Tui Development Drilling  
Applications (EEZ100016)

Response to the Board's  
Request for Further  
Information under section  
54 EEZ Act and Other  
Further Information -  
Notified Marine Consent  
and Marine Discharge  
Consent Applications

July 2018

Figure 3.2 Proposed Anchoring Design and Disturbance Calculations

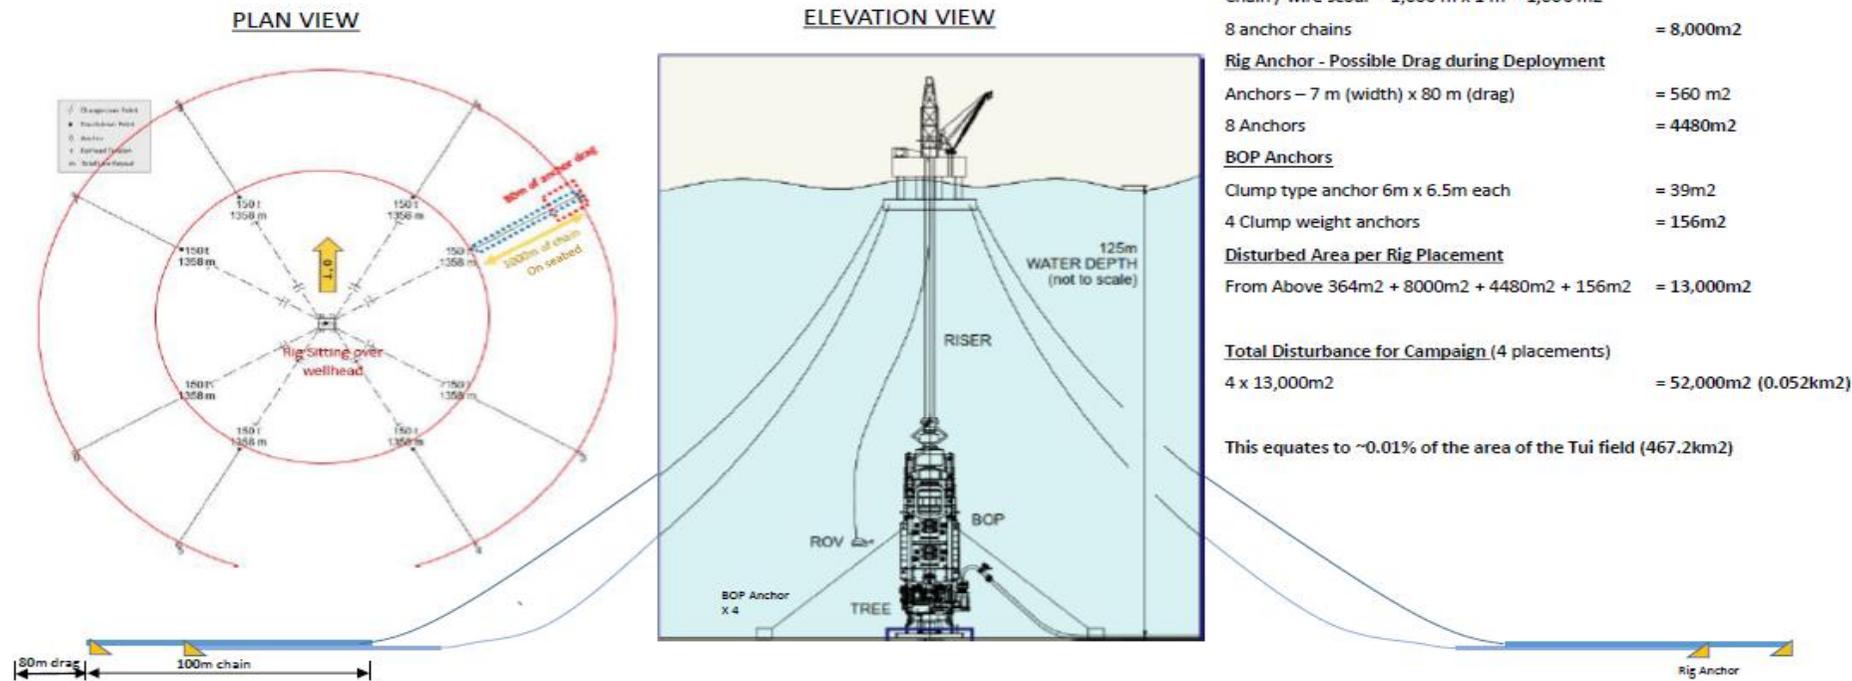
4a. *Provide confirmation on the layout of chain, wire and anchor spread to be used for anchoring the drilling rig, once it has been chosen.*

Based on the configuration of anchors described above, the expected anchoring configuration, layout of chain and calculations for assessing anchoring disturbance are shown in *Figure 3.2*. The anticipated area of seabed disturbance from anchoring will be approximately 13,000 m<sup>2</sup> per placement for drilling. The total area of seabed disturbance for all four placements is estimated to be 52,000 m<sup>2</sup>. This area of disturbance equates to approximately 0.01% of the area of the Tui Permit (PMP38158).

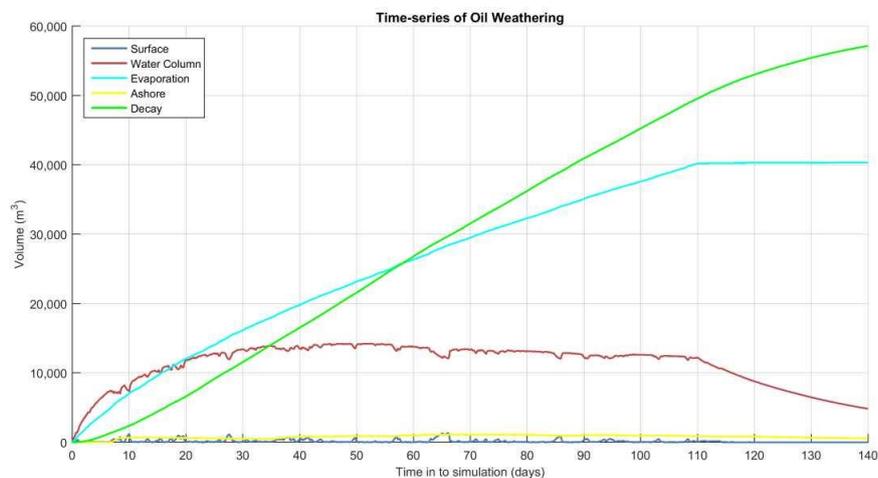
10. Provide a summary of the mass balance at the end of simulations, specifically explaining the fate of the persistent fraction.

“In order to respond to this, it is helpful to look at examples of the fates graphs for one of the spill simulations conducted as shown below. The example below shows the scenario that produced the maximum volume of oil ashore during any of the simulations conducted. The time series below shows that the residual oil components are significantly dispersed at sea due to the dispersive nature of the Tui Crude Oil (waxy residual above its pour point) which is then available for decay over time. Due to the varying currents, the crude dispersed into the water column occurs most often in deep water, allowing for dilution. Being a light crude, there is also significant and rapid evaporation of the volatile components. Sea surface exposure only occurs during light wind conditions and hence minimizing the volumes coming ashore.

Specifically the mass balance (above) of this example demonstrates that the spill initially occurred during rough weather and mixes into near surface waters of the water column due to the high energy mixing. In this example, some oil comes ashore after 8 days as this rough weather abates and surface slicks start to form around day 7. Over time, the high energy moderate to rough weather events come (no surface slicks and subsurface oil is mixed deeper and moved around) and go (near surface water column oil floats to makes surface slicks). Ultimately, the degree of mixing in this offshore region ensures that crude oil and diesel is dispersed while allowing for some evaporation and decay. Further, the flow rate of the spill reduces with time, and hence prevents any accumulation within the water column after day 30 as shown in the above example time series. Other mass balances show similar patterns, just the timing of the moderate to rough weather events changes for each simulation.”

Figure A.1 Management of Drainage and Hazardous Substances on Board the HYSY 982 Drilling Rig

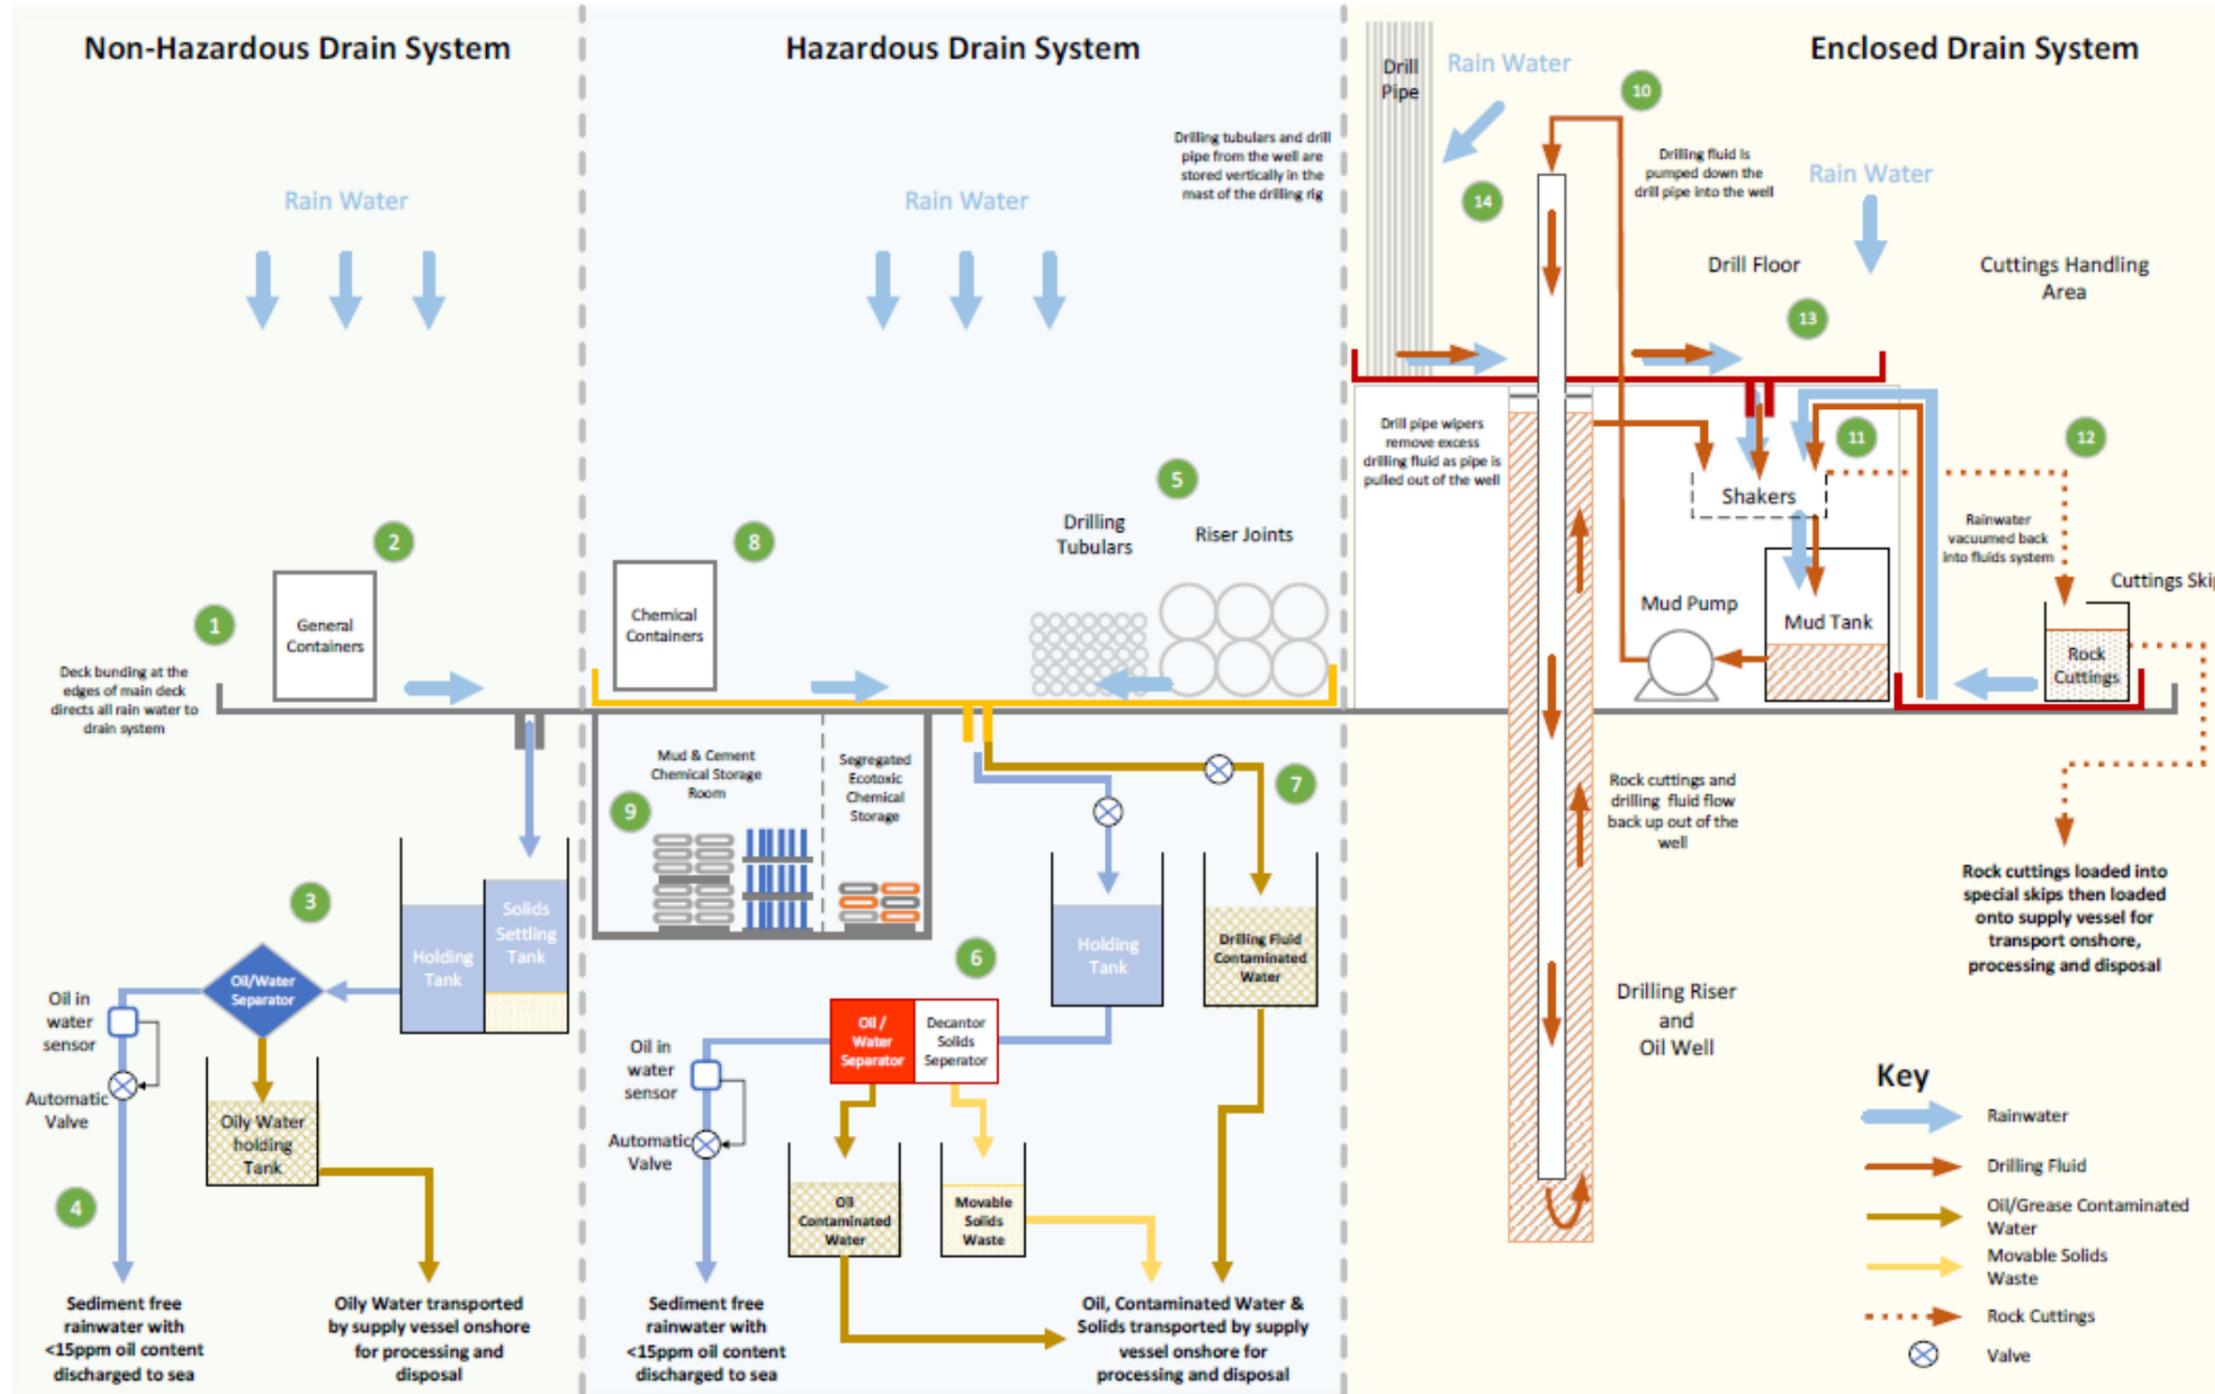
3. *Provide the expected layout and design of the Offshore Processing Drainage system once the drilling rig is selected.*

Accordingly, further information on the expected configuration of the areas where harmful substances are stored and used, and the potential for these products to enter deck drains, is now able to be provided. A summary description of the deck drainage and hazardous substances storage and handling procedures are provided below and a detailed illustration is attached to this report as *Annexure A*.

- All storage of bulk drilling muds, cementing products and other harmful substances will be in fully enclosed areas in which any spills do not have potential to enter the offshore processing drainage;

- Drill pipe will be stored in an enclosed area where any run-off of residual drilling muds is collected and recirculated into the closed loop mud system (i.e. this runoff will not enter offshore processing drainage);

- Only equipment that is being changed out for technical reasons would be stored on deck areas where runoff has potential to enter the deck drainage. All runoff from this deck area will be directed to the hazardous drain systems for settlement of solids and processing through the oil filtering equipment;

- As drill cuttings are now being returned to shore for disposal, these will be stored in sealed and covered skips where they can be offloaded to supply vessels for transport. These skips will be contained in a fully bunded area, allowing for containment of any spillage so that it can be cleaned up before any runoff is directed to the hazardous drain system.
